Re: GE-Pittsfield/Housatonic River Site
Unkamet Brook Area (GECD170)
Addendum to Pre-Design Investigation Report

GENERAL ELECTRIC COMPANY
PITTSFIELD, MASSACHUSETTS
ADDENDUM TO PRE-DESIGN INVESTIGATION REPORT FOR UNKAMET BROOK AREA

PARCEL K11-7-8 - PROPOSED AND EXISTING PCB SOIL SAMPLE LOCATIONS

FIGURE 1

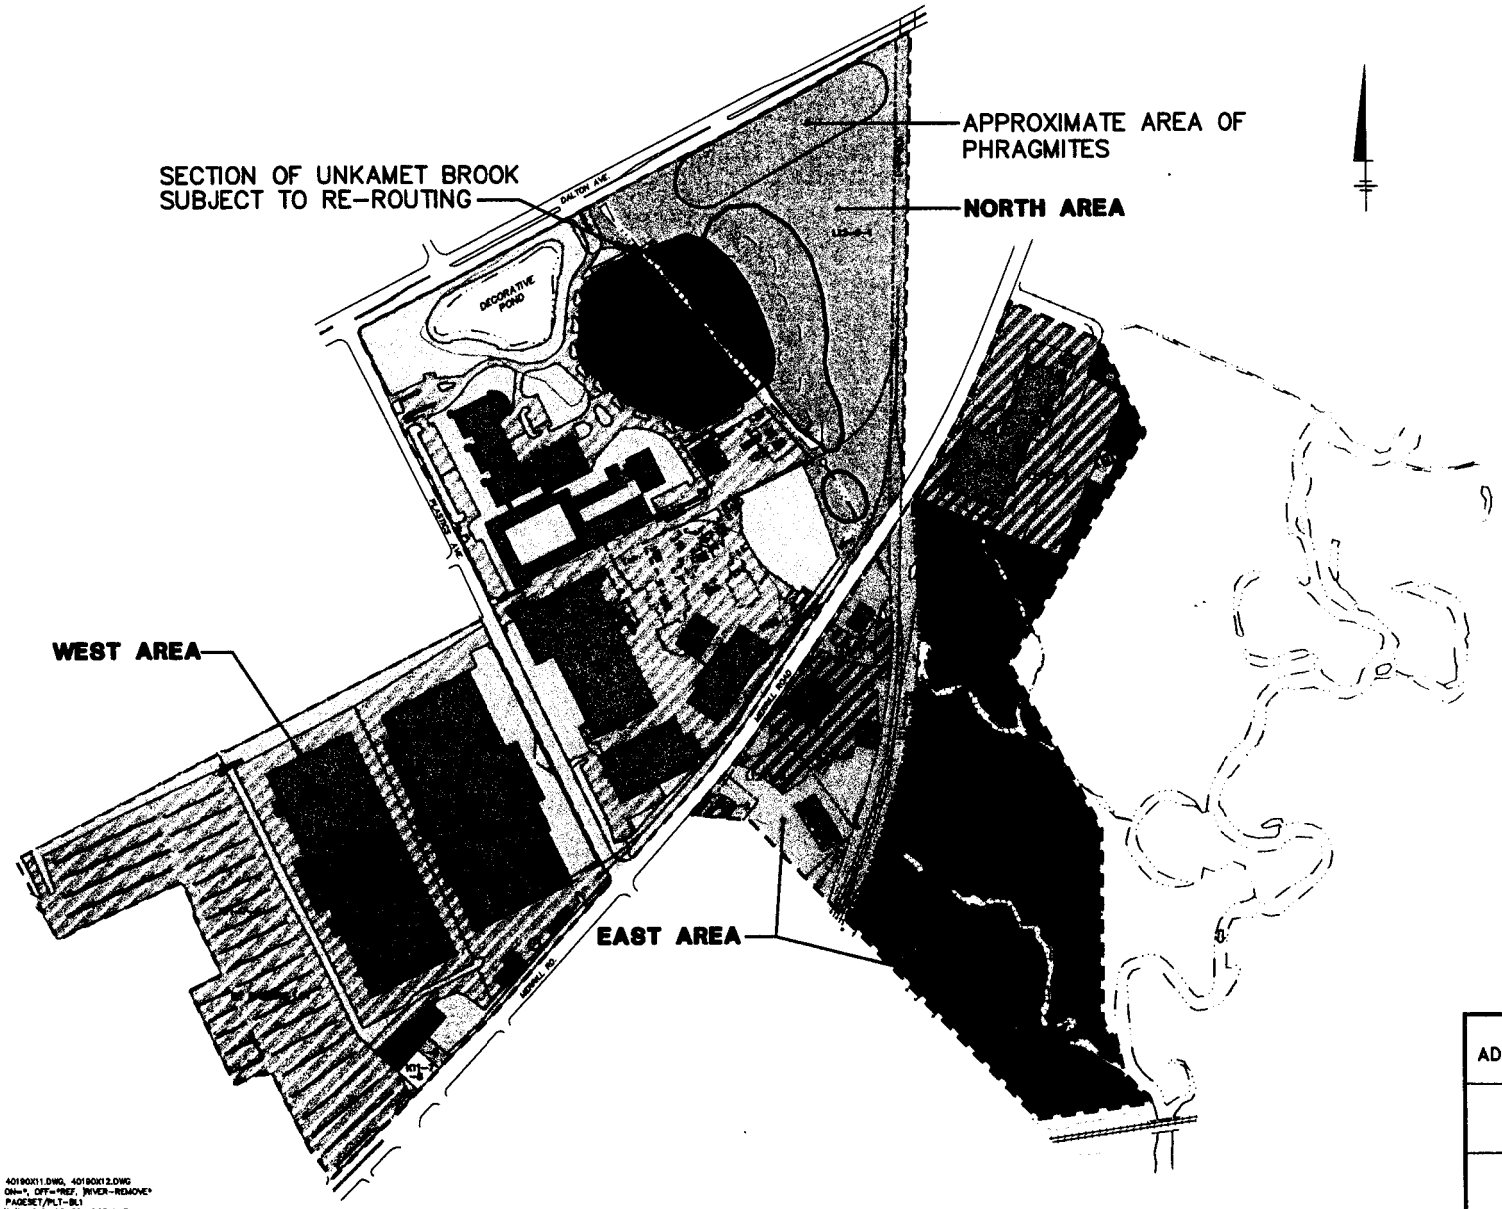
GE has determined that one of the commercial/industrial properties in this area, Parcel K11-7-8 (whose location is shown on Figure 1), likely already meets the soil-related Performance Standards that would apply to residential properties. Achieving the residential Performance Standards at this property would avoid the need to seek a Grant of Environmental Restriction and Easement (ERE) or to implement a Conditional Solution at this property. However, application to this property of the Performance Standards for residential properties would require additional sampling for PCBs on a sampling grid that is consistent with the requirements for residential properties in the *Statement of Work for Removal Actions Outside the River* (SOW). Accordingly, to complete an evaluation of whether this property meets the residential Performance Standards, GE proposes to conduct additional sampling at that property.

FIGURE 2

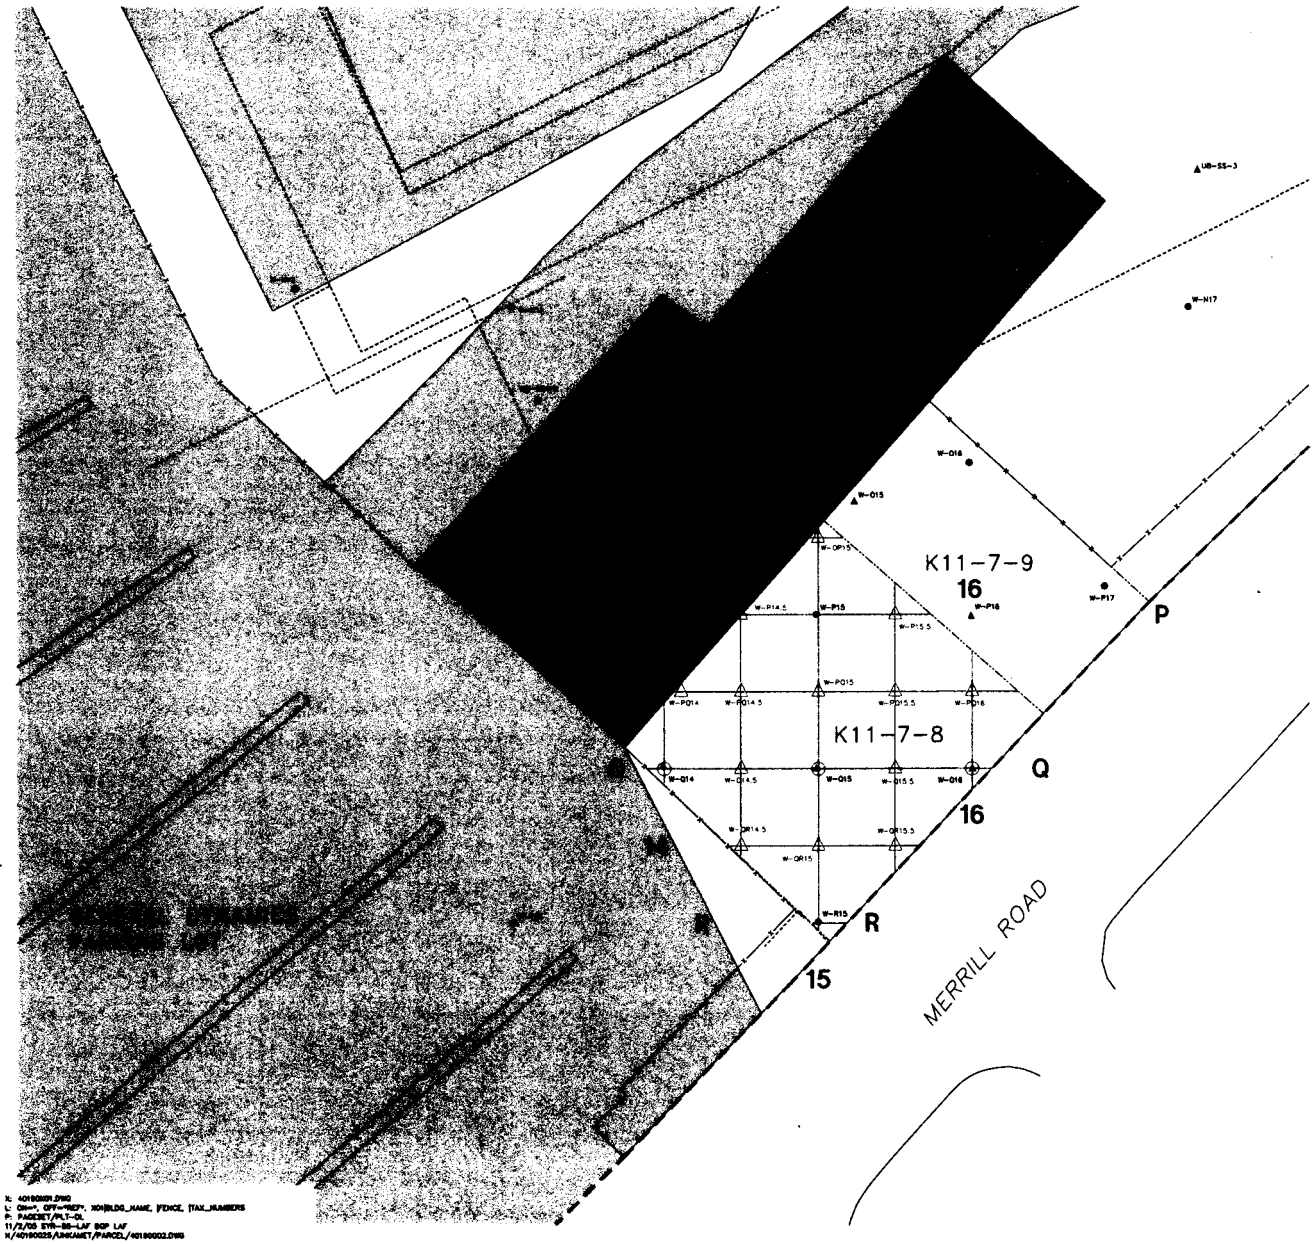
The SOW requires PCB sampling of residential properties at the Former Oxbow Areas on a 25-foot grid for the top foot of soil and a 50-foot grid for soil deeper than one foot (SOW, Technical Attachment D, p. 7). Assuming that these same grids would apply to residential properties at the Unkamet Brook Area (if there were any), such grids have been superimposed on Parcel K11-7-8, starting with the grids previously used in the pre-design investigation of this portion of the Unkamet Brook Area. These grids are shown on Figure 2.

Although the SOW states that samples from the top foot at residential properties should be collected from the 0- to 0.5-foot and 0.5 to 1-foot depth intervals, EPA has approved an alternative sampling approach for the residential properties at Former Oxbow Areas J and K, under which surface samples were collected from the 0- to 1-foot depth increment. Applying that same approach here, GE proposes to collect samples from the 0- to 1-foot depth increment at the 25-foot grid nodes on Parcel K11-7-8 where such surface samples were not previously collected. These additional sampling locations are identified on Figure 2. These samples will be submitted for PCB analysis.

In addition, GE proposes to advance soil borings at the 50-foot grid nodes on this property where borings were not previously advanced for the collection of subsurface samples. These additional soil boring locations are also shown on Figure 2. At each of these boring locations, in addition to the collection of surface samples from the 0- to 1-foot depth increment (at locations where surface samples were not previously collected), subsurface samples will be collected, beginning at one foot below the ground surface (bgs), to a depth of 15 feet. Although the SOW states that subsurface samples at residential properties should be collected in two-foot depth intervals, GE proposes, for this property, to collect the subsurface samples from depth increments of 1 to 3 feet, 3 to 6 feet, and 6 to 15 feet for two reasons: (1) for consistency with the existing subsurface PCB data from this property (which were collected in those depth increments); and (2) because the existing subsurface PCB data from this property show no detected PCBs. The samples from the 0- to 1-foot and 1- to 3-foot depth increments will be submitted for PCB analysis, and the deeper samples will be held at the laboratory and will be analyzed for PCBs iteratively if samples from the depth increment above them show detected PCBs. For purposes of applying the residential Performance Standard of 2 ppm, if PCBs are detected in any sample deeper than one foot, all the existing and new PCB data from depth increments from one foot bgs to the depth at which PCBs were detected will be averaged, using the spatial averaging procedures specified in the SOW, to determine the average PCB concentration in the 1- to X-foot depth increment, where X equals the depth at which PCB were detected at the property.
